Informal document GRSP-57-20
(57th GRSP, 18-22 May 2015,
agenda item 14)

**Proposal for Proposal for the 01 series of amendments to
Regulation No. 129 (Enhanced Child Restraint Systems) –
Proposal of amendments to
ECE/TRANS/WP.29/GRSP/2015/9.**

Submitted by the expert from France*

Annex 2, insert at the end two new approval marks, to read:

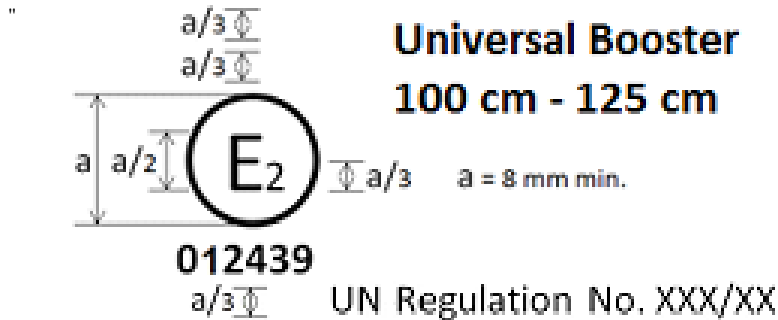
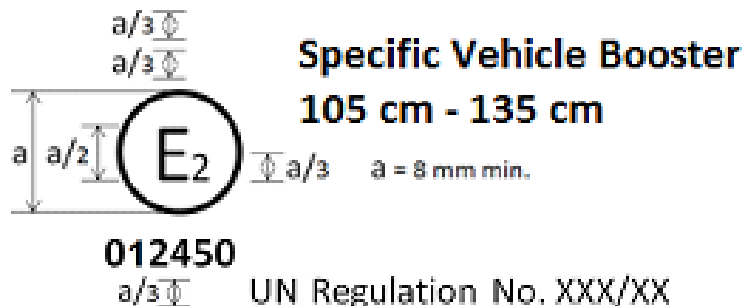
The Enhanced Child Restraint System bearing the above approval mark can be fitted in any Universal Booster seating position and used for the 100 cm - 125 cm size range; it is approved in France (E 2) under the number 012439. The approval number indicates that the approval was granted in accordance with the requirements of the Regulation concerning the approval of Enhanced Child Restraint Systems used on-board of motor vehicles as amended by the 01 series of amendments. In addition, the name of the regulation is to be identified on the approval mark followed by the series of amendment according to which the approval has been granted.

The Enhanced Child Restraint System bearing the above approval mark is a device not capable of being fitted in every vehicle but capable of being used for the 105 cm - 135 cm size range; it is approved in France (E 2) under the number 012450. The approval number indicates that the approval was granted in accordance with the requirements of the Regulation concerning the approval of Specific Vehicle Booster Enhanced Child Restraint Systems used onboard of motor vehicles as amended by the 01 series of amendments. In addition the name of the regulation has to be identified on the approval mark followed by the series of amendment according to which the approval has been granted."

Figure 1
Dimensions in mm of the seat and the seat cushions

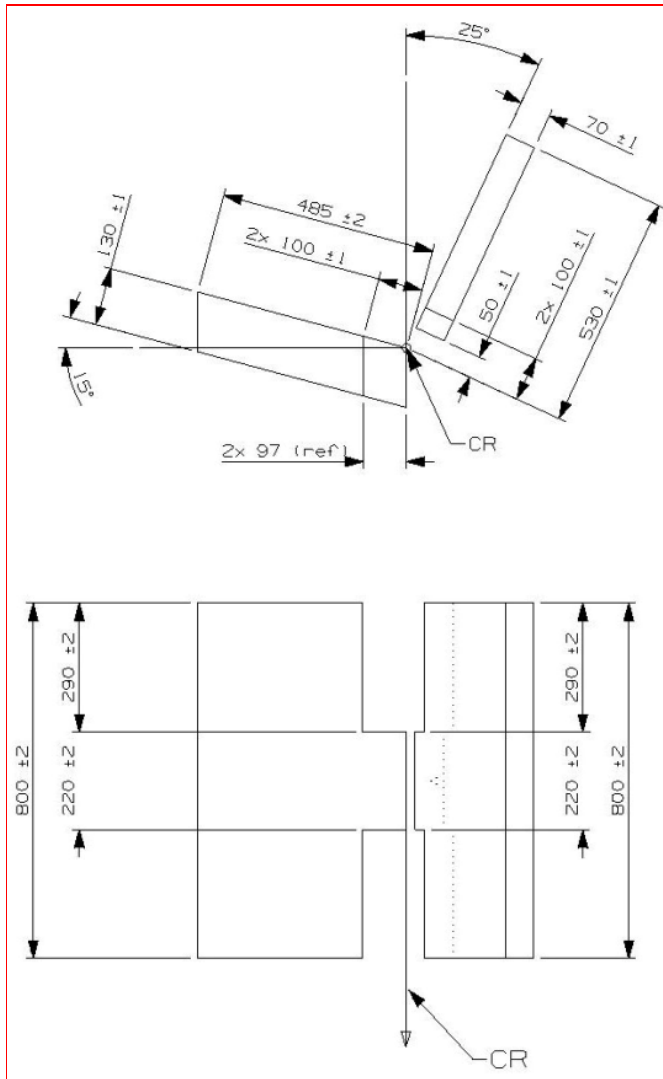
- "3.1.2. Rigid seating, **made from a rigid metal sheet**, dimensions of which are given in Appendix 1 to this annex. ~~The rear part of the seating is made from a rigid sheet metal.~~ The front part of the seating is also made of a 20 mm diameter tube;"

Figure 1
Standard seat belt configurations

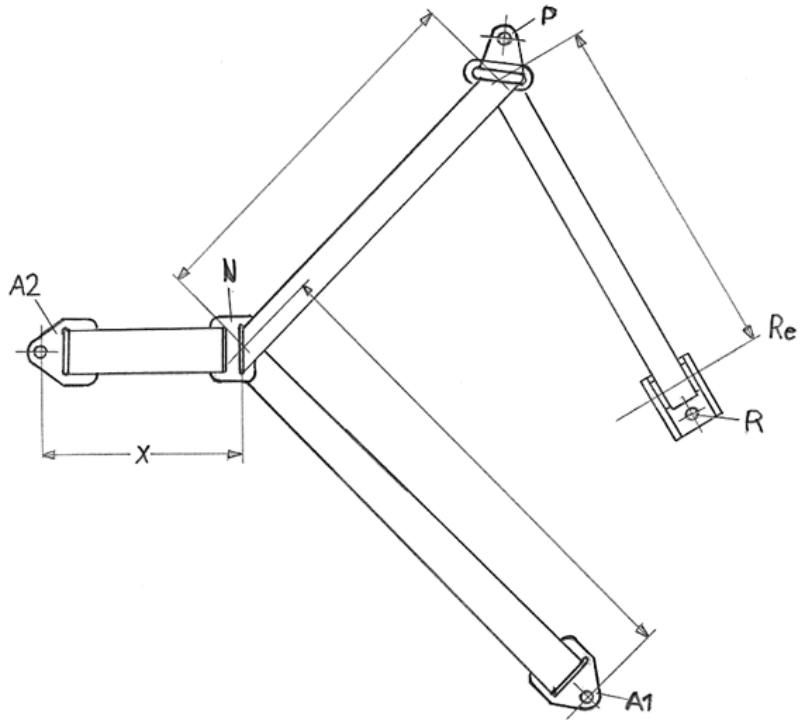
1. The safety-belt for the dynamic test and for the maximum length requirements shall be made according to one of the two configurations shown in Figure 1. These are a three-point retracting belt system.

2. The three-point retracting belt has the following rigid parts: a retractor (R), a pillar loop (P), two anchorage points (A1 and A2) (see Figure 1), and a central part (N, in detail in Figure 3). The retractor shall comply with the requirements of Regulation No. 16 (paragraph 6.2.5.2.2.) for retraction force. The retractor spool diameter is 33 ± 0.5 mm [(example is given in Mutual Resolution No. 1 (M.R.1))].

The value of X in Figure 1 below is 200 ± 5 mm. The effective strap length between A1 and the centre line of the retractor spool Re (when the webbing is fully extracted including the minimum length of 150 mm for testing of Enhanced Child Restraint System shall be $[2820] \pm 5$ mm when measured in a straight line without load and on a horizontal surface. This length may be increased for the testing of restricted categories; for all categories with the Enhanced Child Restraint System installed, there shall be a minimum of 150 mm of strap length on the retractor spool.

Figure 1
Measuring Device for a Universal Booster Cushion

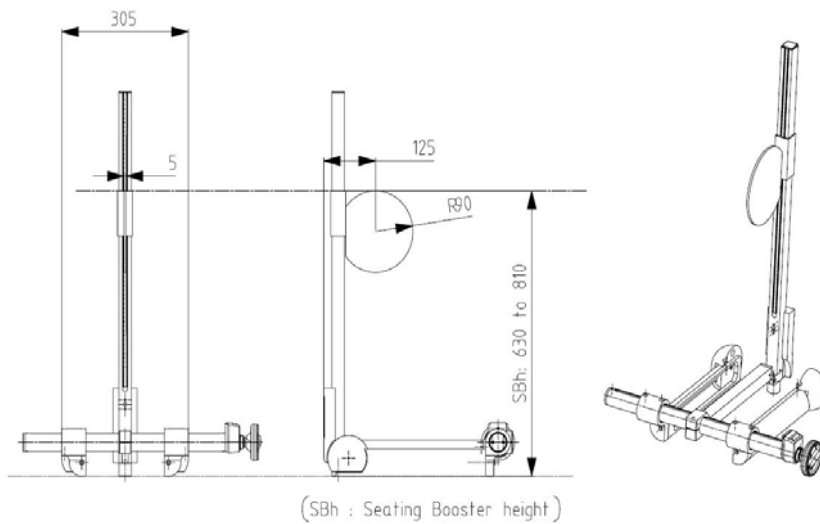
The measuring device to assess a universal Booster Cushion is described in Figure 1. This measuring device shall have a mass of 10 ± 1 kg.

Figure 2
Installation of the Measuring Device to measure Z5 and Z95

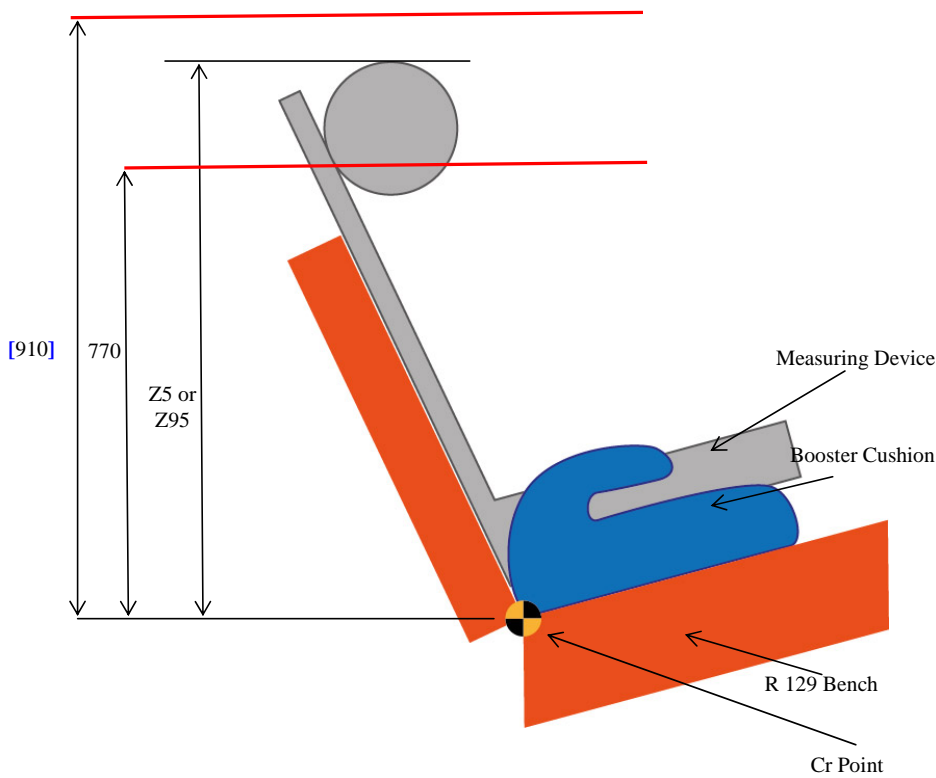
- 2.1. Using Table 1 below, adjust the Seating Booster height (SBh) to the 5th percentile seating height of the lower stature defined for the Booster Cushion.
- 2.2. Position the Booster Cushion on the Regulation No. 129 test bench.
- 2.3. Position the Booster Measuring Device on the Booster Cushion as defined in Figure 2.
- 2.4. Measure the upper position of the cylinder relative to the Cr point in the Z direction: Z5.
- 2.5. Using Table 1 below, adjust the Seating Booster height (SBh) to the 95th percentile seating height of the taller stature defined for the Booster Cushion.
